REGULATORY TRAFFIC CONTROL DEVICE
PLACE, MODIFIED, OR REMOVED

FISCAL YEAR 2020 QUATER 3

ALACHUA COUNTY PUBLIC WORKS
ENGINEERING

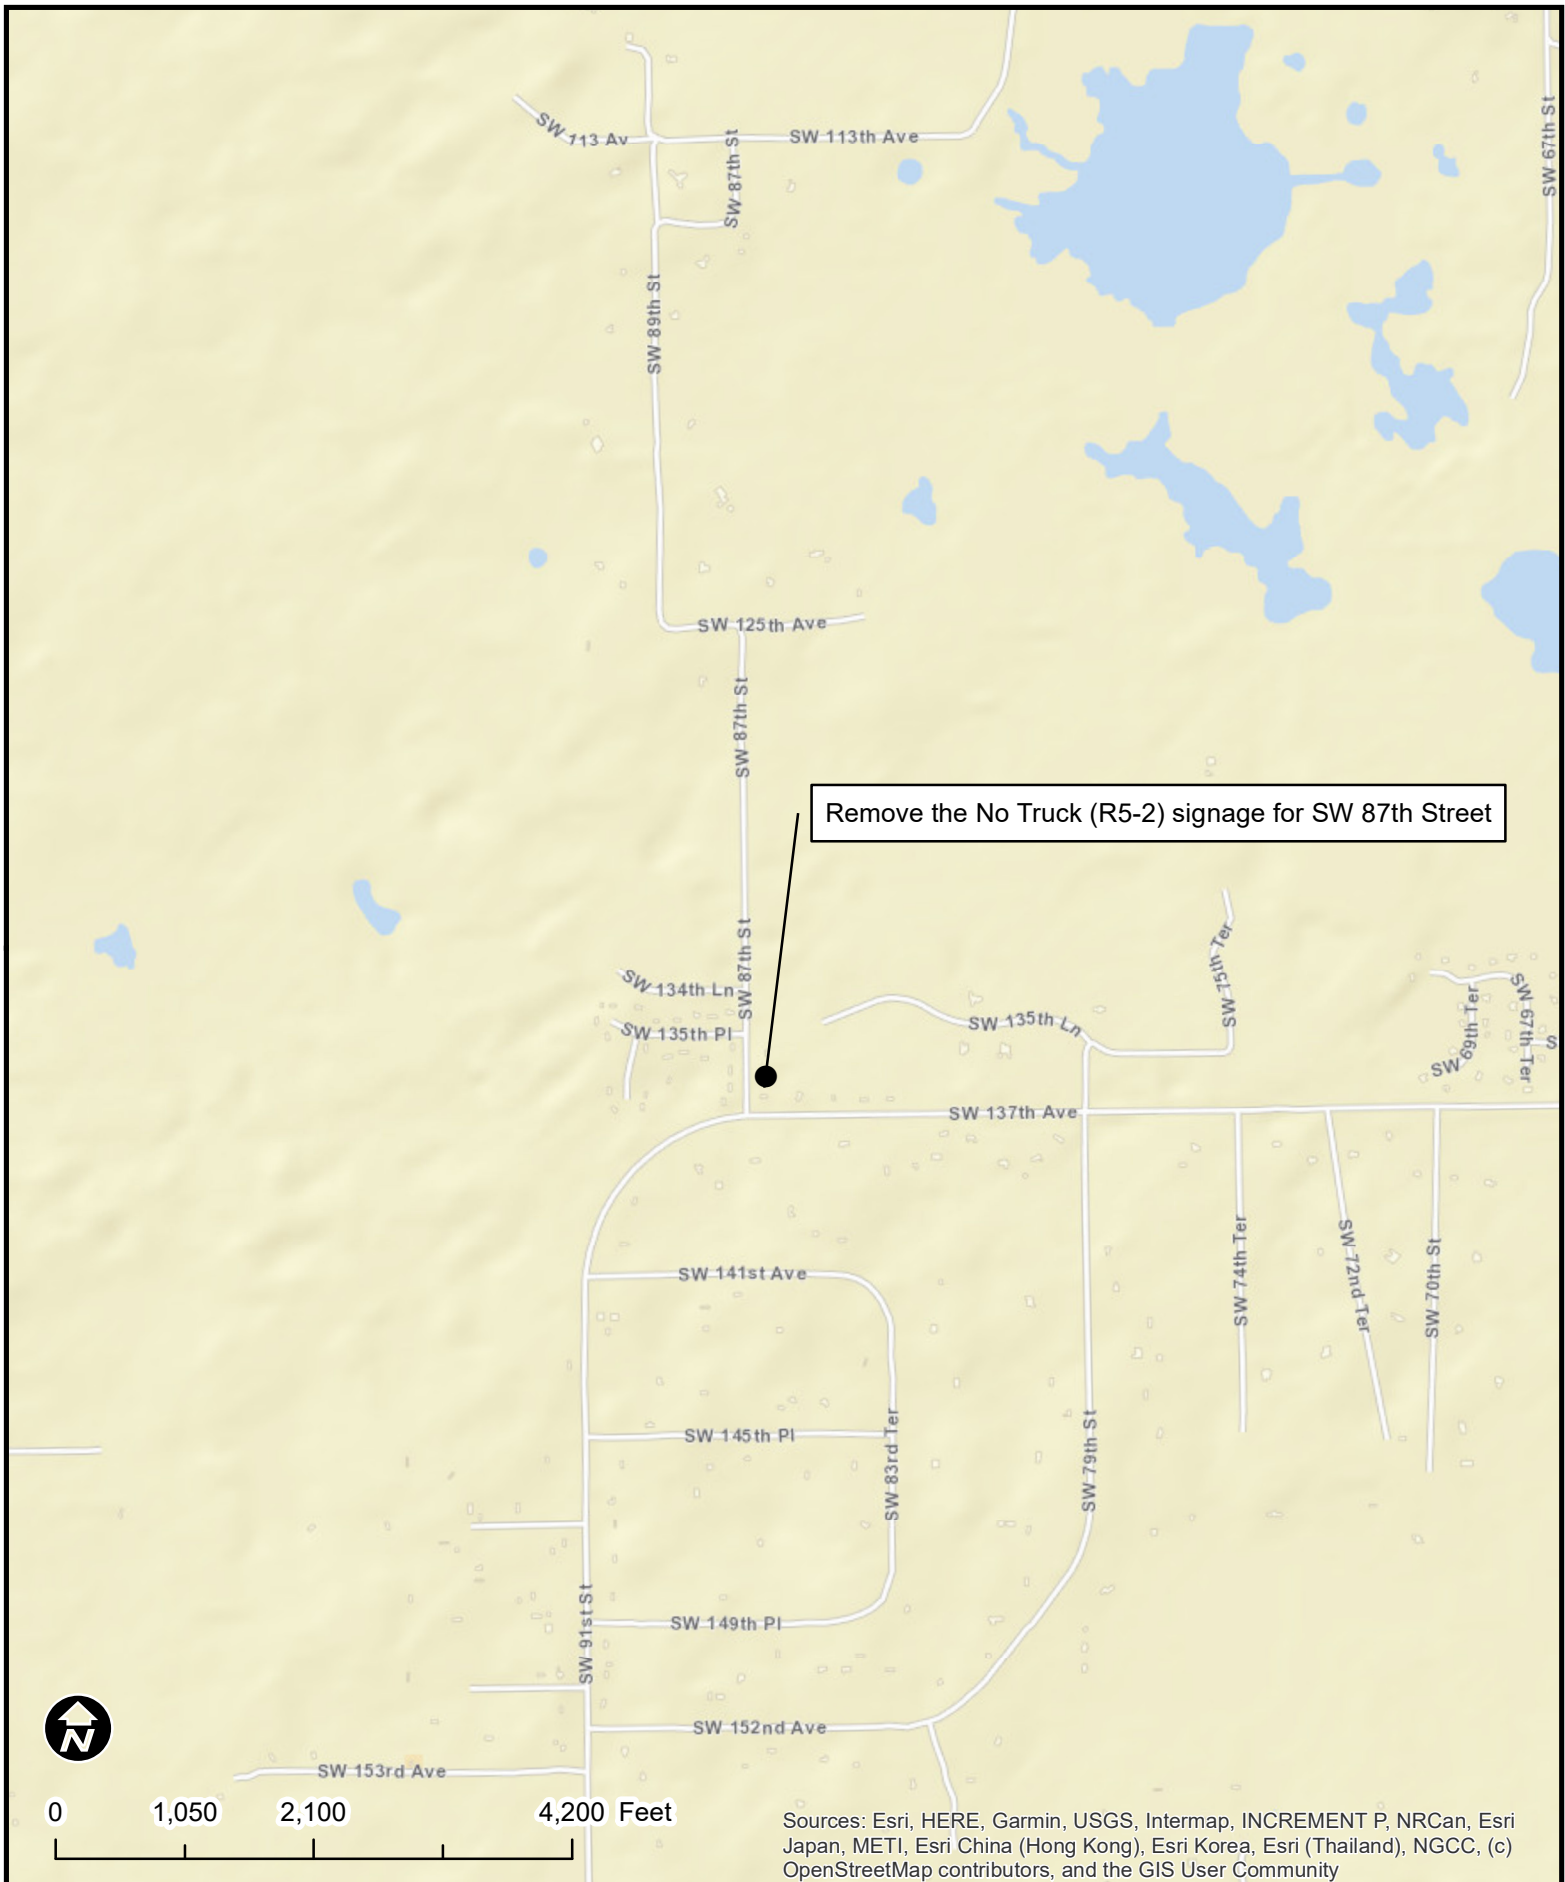
Remove the regulatory "Yield" (R1-2) for the northbound traffic from US 441 and install a regulatory "Yield" sign (R1-2) for the southbound US 441 traffic onto NW 43rd Street. Additional advance warning signs will be installed per the MUTCD.
